UNITED STATES PATENT AND TRADEMARK OFFICE

APPLICATION NO.	FILING DATE	FIRST NAMED INVENTOR	ATTORNEY DOCKET NO.	CONFIRMATION NO.
10/771,627	02/05/2004	Hiroshi Kuzuya	26B-025	9496
23400	7590	02/22/2005	EXAMINER	
POSZ & BETHARDS, PLC 11250 ROGER BACON DRIVE SUITE 10 RESTON, VA 20190			PATEL, VISHAL A	
			ART UNIT	PAPER NUMBER
			3676

Office Action Summary

DETAILED ACTION

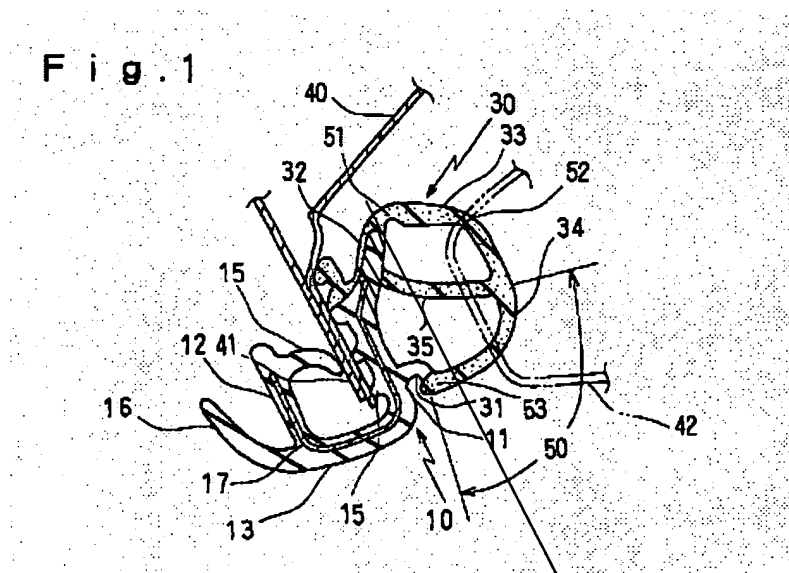
Oda discloses a weather strip comprising a trimming portion having a substantially U-shaped cross section (U-shape that has 17) and attachable to a surrounding part of a door opening of a vehicle (intended use), the trimming portion having an outer side wall portion (outer side wall portion having two lips 15), an inner side wall portion (inner side wall portion having one lip 15), and a connecting portion (13) for connecting the outer and inner side wall portions to each other. The weather strip having a hollow seal portion (hollow portion that contacts 42) connected to the trimming portion at a first connection portion (first connection portion having 31), which is placed substantially at a boundary portion between the connection portion and the outer side wall portion. The hollow seal portion having at a second connection portion (second connection portion by the additional cross-hatching in the attached figure), which is placed closer to a leading end of the outer side wall portion than the first connection portion and adapted to be more flexible than the trimming portion. The weather strip having a projecting portion

(projection portion having the cross-hatching in the attached figure 1) provided in the second connection portion in such a way as to extend from the outer side wall portion of the trimming portion, wherein a thickness (thickness formed by the first cross-hatching line closest to the trimming portion) of the projecting portion along a direction, in which the outer side wall portion extends, is larger than a thickness of a part of the seal portion, which is pressure-contacted to a peripheral portion of the door (the thickness of the projection is larger than the thickness of a part 52 of the seal portion that contacts 42).

The thickness of a base end part (this is also defined by the first cross-hatching line, see attached figure) of the projection portion is equal to or more than twice the thickness of the part of the seal portion.

A thickness of base end part of the projection portion is equal to or more than one-fourth of a length (length from the first cross hatching line to the leading end part that contacts 51) from a leading end part (leading end part that contacts 51) of the outer side wall portion of a boundary portion between the connecting portion and the base end part.

A thickness of the leading end part of the projection is equal to or more than twice the thickness of the part of the seal portion (the leading end part has a thickness that is equal or twice the thickness of the part of the seal portion).

A projection length from a base end part of the projection portion to a leading end part thereof (length of the projection normal from the outer side wall) is larger than the thickness of the part of the seal portion.

The projection length is equal to or more than twice a thickness of the part of the seal portion.

A cross sectional area (area of projecting portion) of the projecting portion is equal to or more than four times an area obtained by square of the thickness of the part of the seal portion.
